CLASS II MODIFICATION 2019, 8.2.2019

BLDG III FIRST & SECOND FLOOR PLANS

A3.1

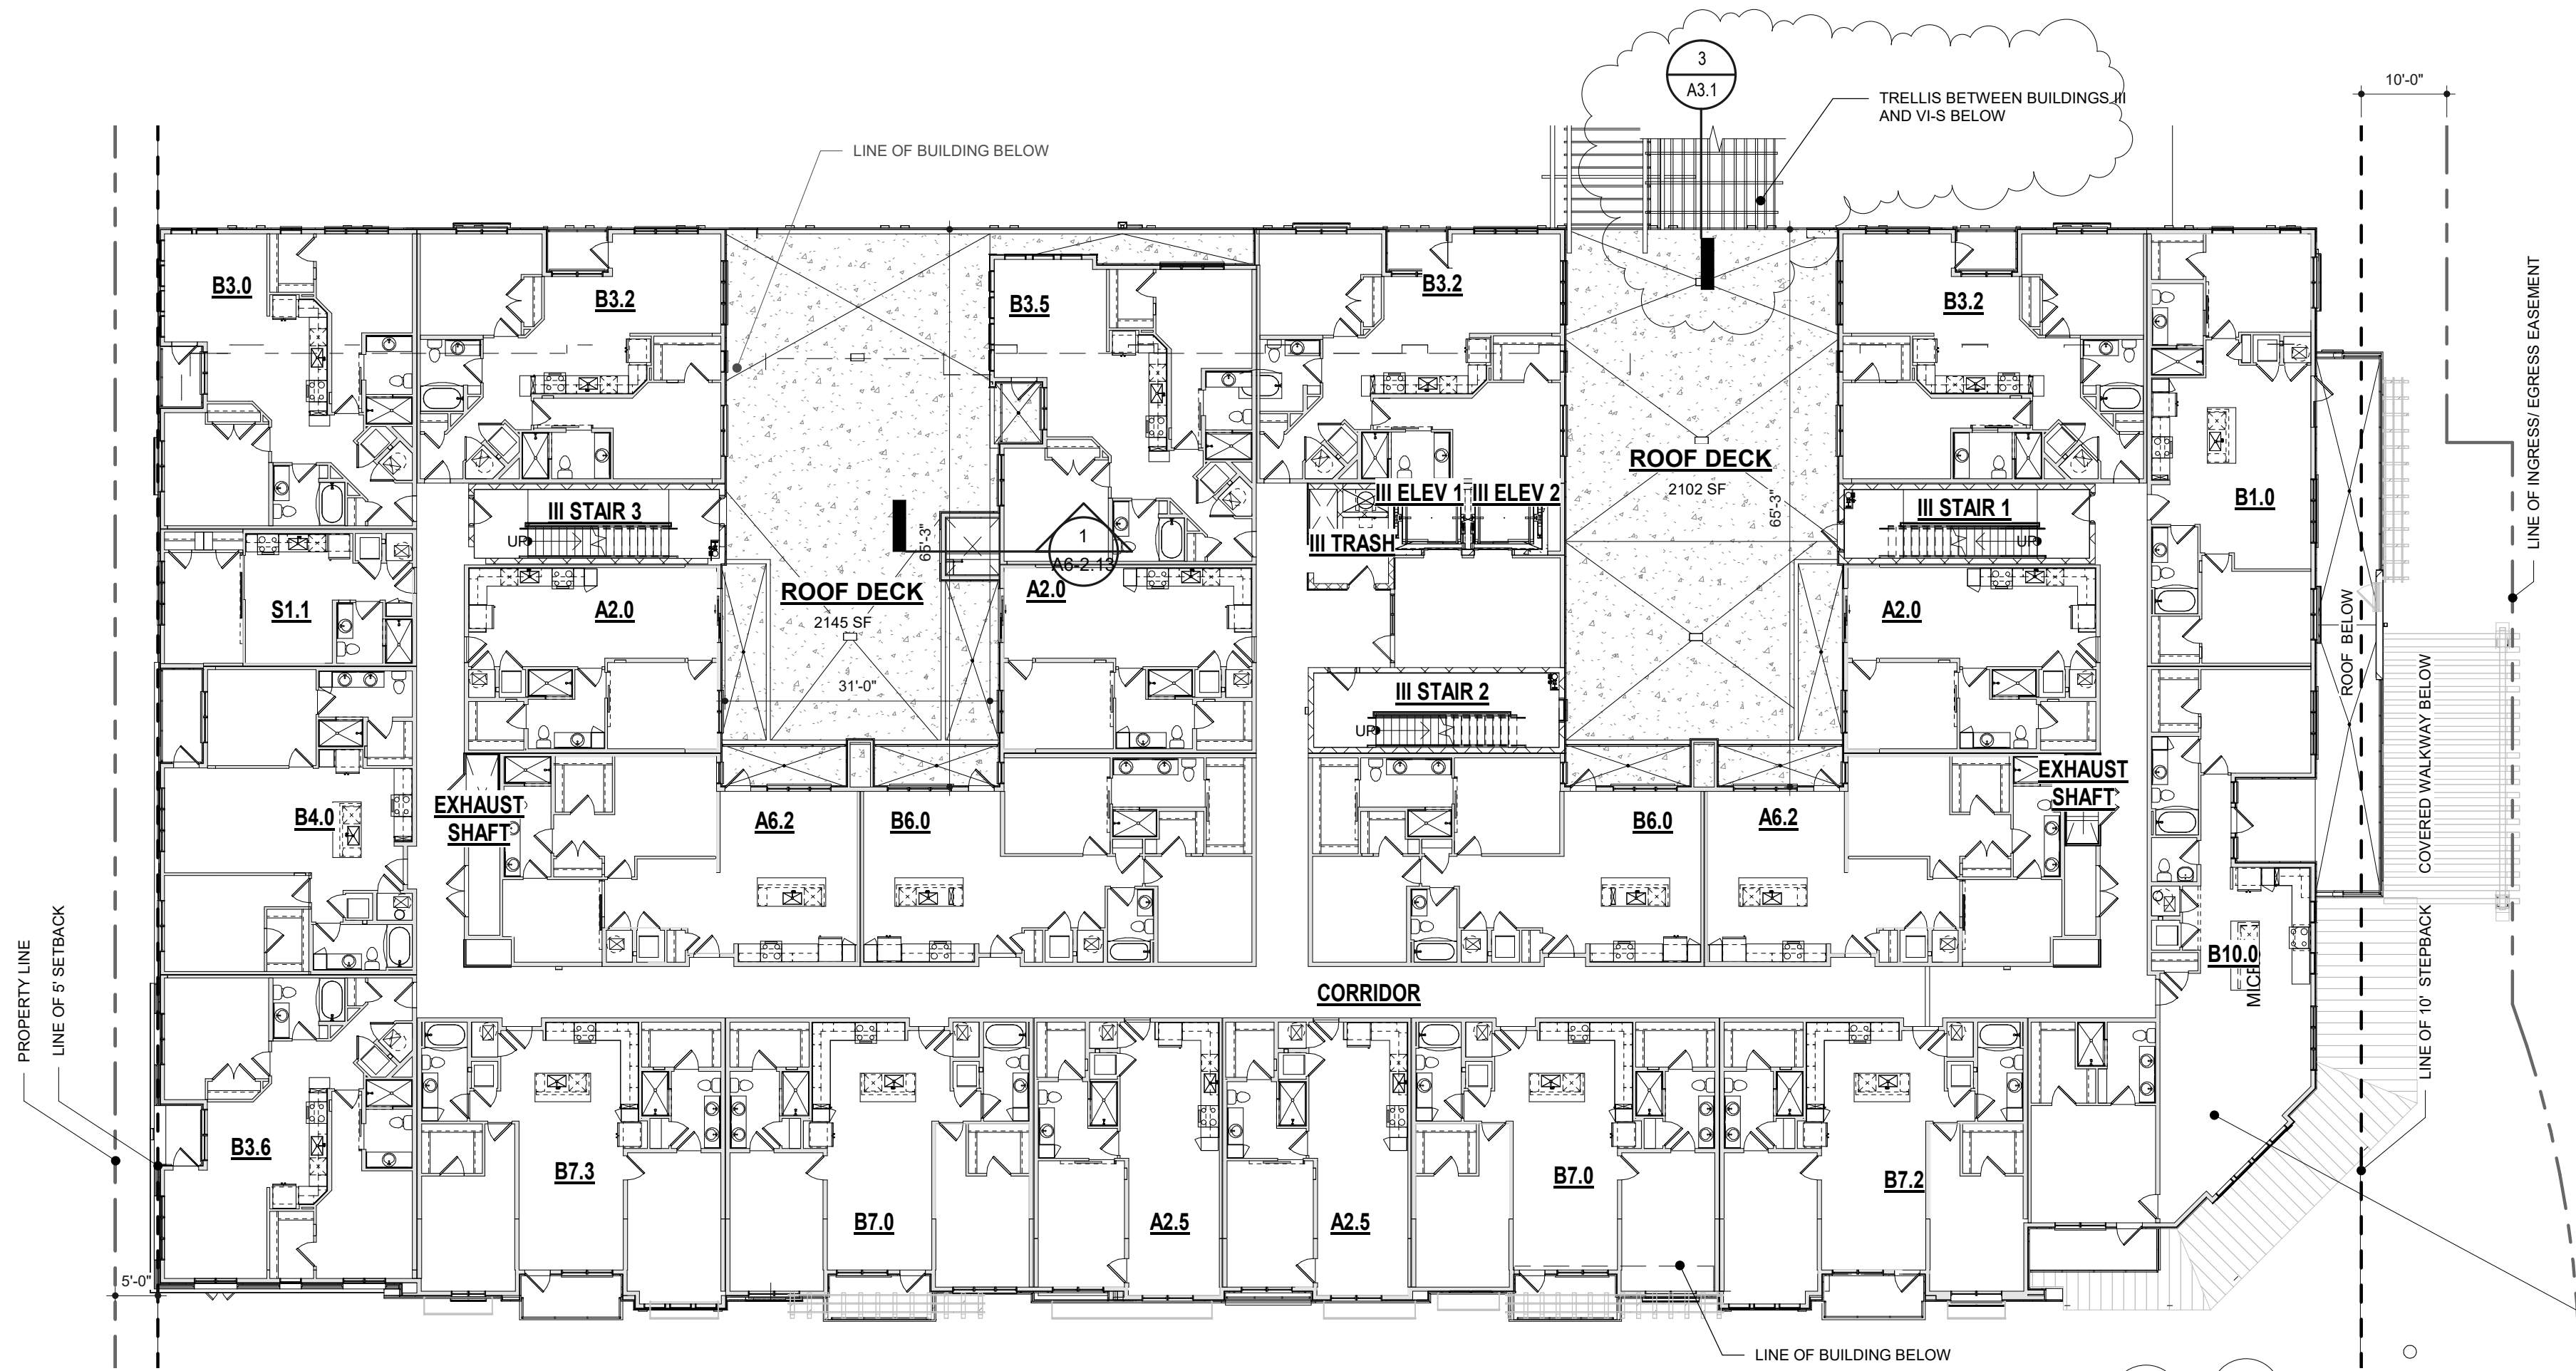
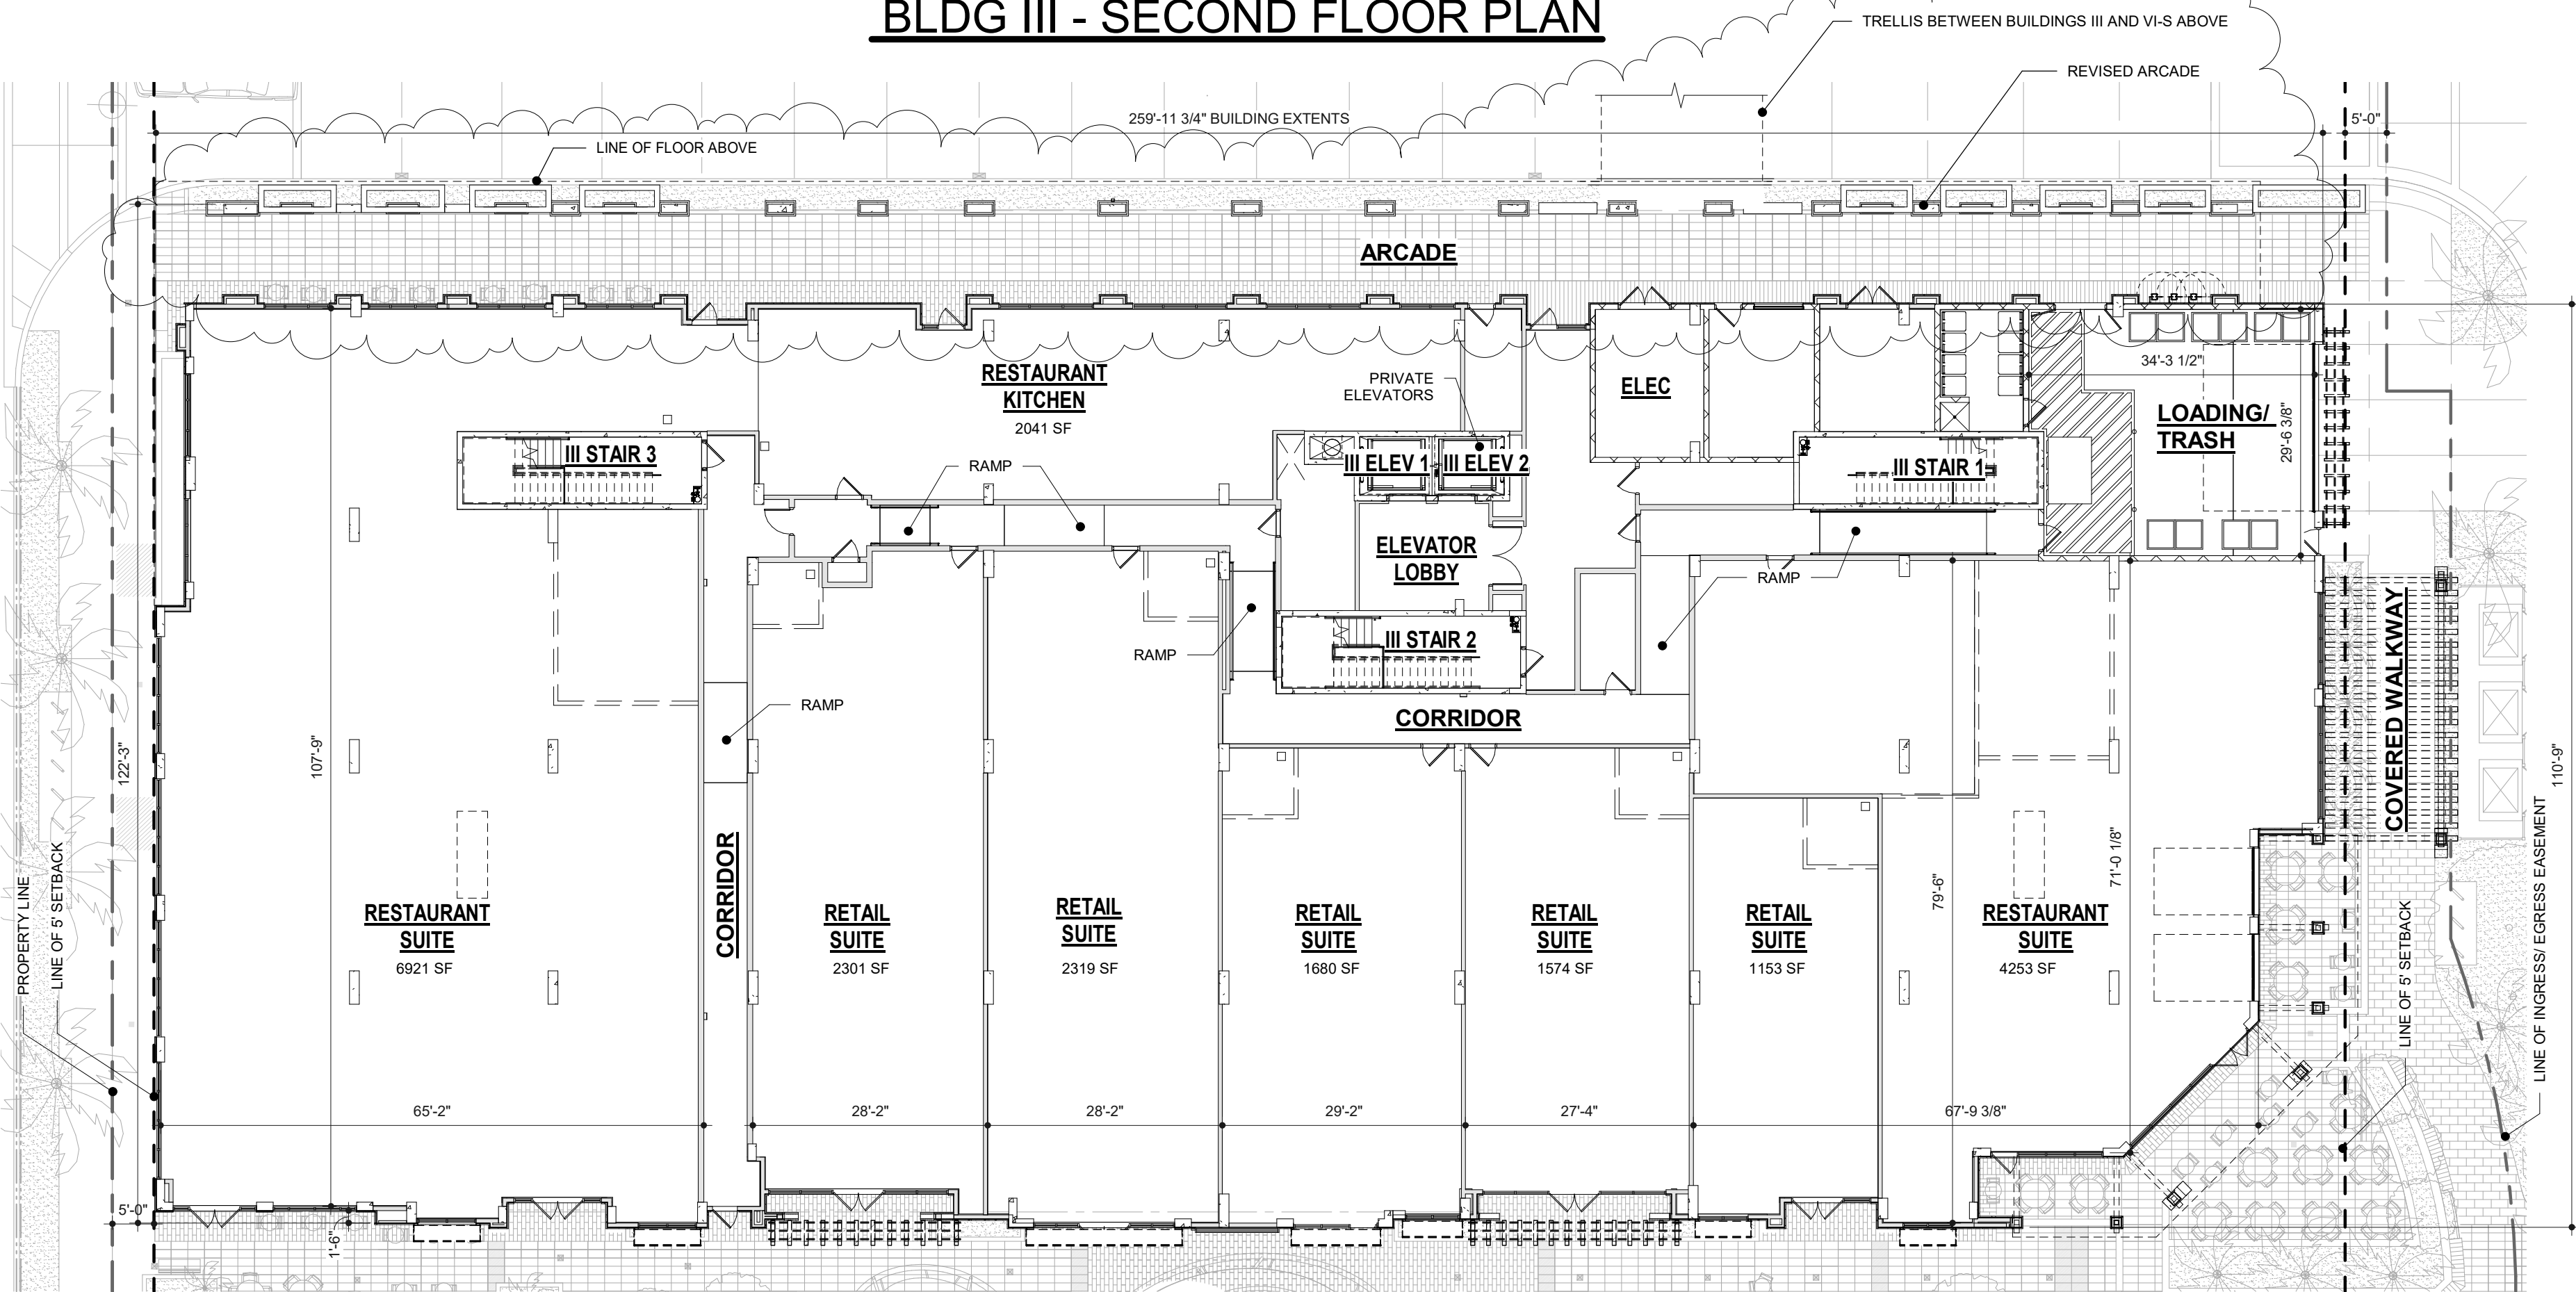
- BUILDING III NORTHWEST FOOTPRINT ADJUSTED DUE TO ADDITION OF RAMP AT NE 6TH AVENUE.
- ADJUSTED EASEMENT LINE ON WEST SIDE OF N.E. 7TH AVE.
- FLOOR PLANS REFLECT RESIDENTIAL UNIT COUNTS.

- REFORMATTED UNIT MATRIX
- SETTLEMENT MODIFICATION 4.21.2017
- ADD ARCADE TO THE NORTH AND REDUCED SQUARE FOOTAGE ACCORDINGLY
- DELETED CANTILEVER ON NORTH AT SECOND FLOOR

3 DECORATIVE CONNECTOR SECTION
1/4" = 1'-0"

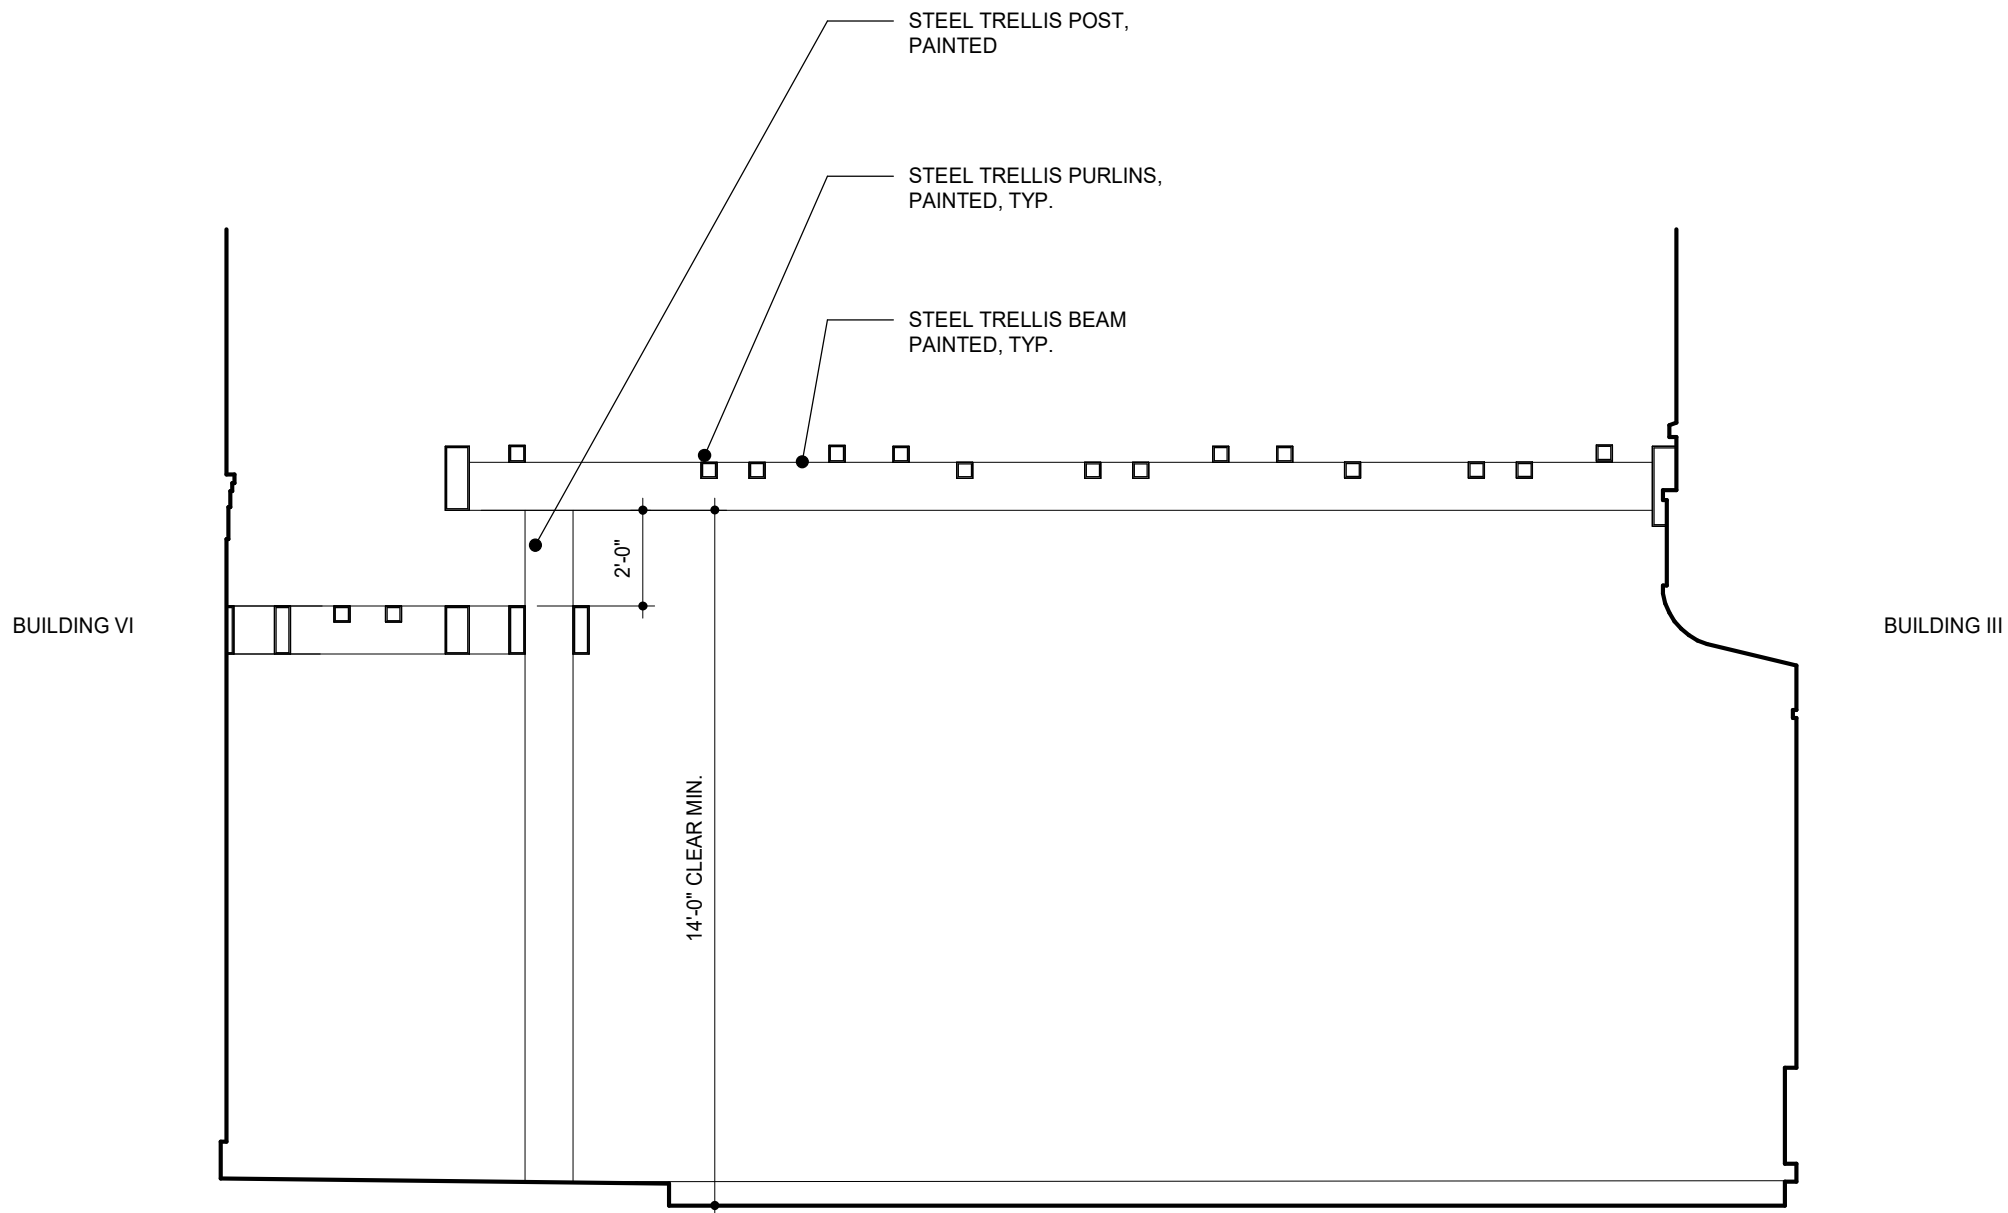
- REVISE DETAIL AT ARCADE
- ADD TRELLIS BETWEEN III & VI-S
